TO:	CHAIR AND MEMBERS – PLANNING & ENVIRONMENT COMMITTEE
FROM:	GEORGE KOTSIFAS, P.ENG MANAGING DIRECTOR, DEVELOPMENT & COMPLIANCE SERVICES & CHIEF BUILDING OFFICIAL
SUBJECT:	APPLICATION BY: 1904812 ONTARIO LIMITED (C/O DOMUS DEVELOPMENT LONDON INC.) 200 VILLAGEWALK BOULEVARD PUBLIC SITE PLAN MEETING SEPTEMBER 19, 2016

REQUESTED ACTION: Approval of an application for Site Plan Approval for the construction of a four (4) storey office building with a Gross Floor Area (GFA) of 3,474 sq m.

Proposed Site Plan

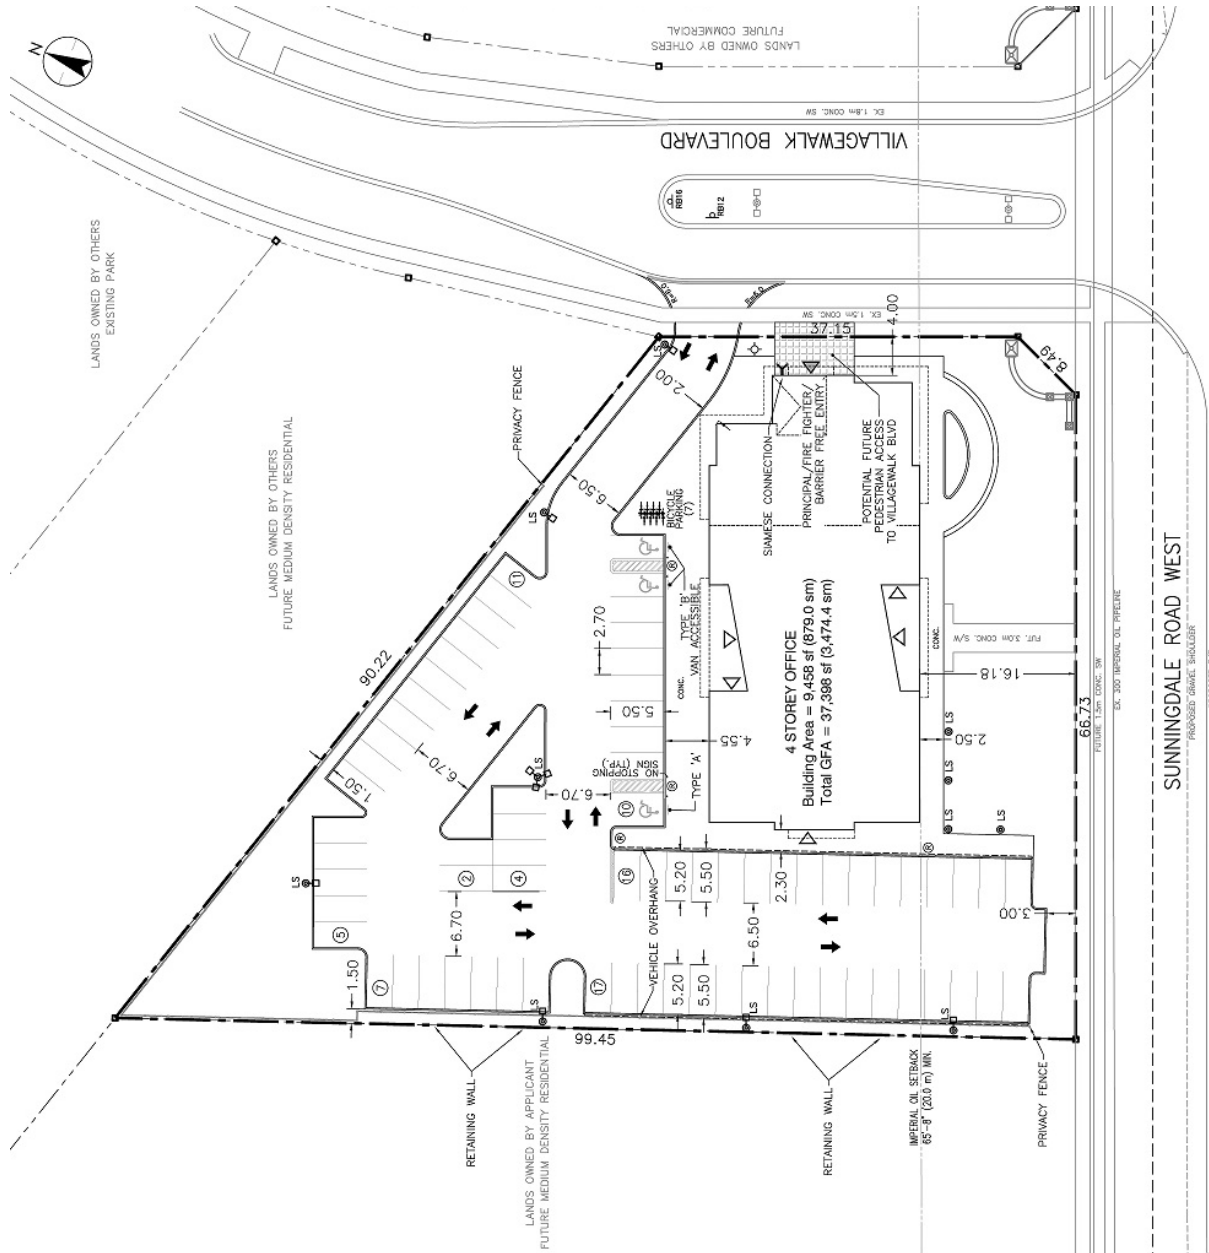
The building is located in the southeast corner of the site approximately 4.0 metres from the property line on Villagewalk Boulevard, and approximately 16 metres from the reserve along Sunningdale Road. An entrance is proposed on the east, to the north of the building. Seventy-two (72) parking spaces are proposed west and north of the building. The streetscape along Sunningdale includes planting areas with trees and low shrubs to screen the parking, and a proposed walkway to connect to the future sidewalk. The principal building entrance is oriented toward the existing sidewalk on Villagewalk.

A privacy fence along the west and north sides of the parking area to help buffer the noise and lighting impacts on the future development(s) is expected to the north and the active residential development to the west. All on-site lighting is oriented to the ground with recessed lighting fixtures to ensure minimal impact on abutting properties. A photometric plan was prepared and details of all external lighting have been provided. The lighting is proposed to be recessed and oriented to the ground and away from existing residential dwellings. Two parking lot light standards are proposed (approximately 5 metres tall) near the west boundary of the parking area. The residential units to the west back onto the proposed 2 metre retaining wall and 1.8 metre privacy fence, reducing the visual impact of light in their rear amenity space. Three street trees are being preserved along Villagewalk Boulevard.

The access into the site is proposed near the northern limit of the site on Villagewalk Boulevard. Standalone signage is proposed to prohibit left-out turning movements along Villagewalk and north-bound U-turns movements, also restricted with a median requiring exiting vehicles to head south to Sunningdale Road. No access is proposed onto Sunningdale Road.

- Acquire permissions from abutting land owner for the proposed site grading and stormwater overland flow route proposed over the property to the north.
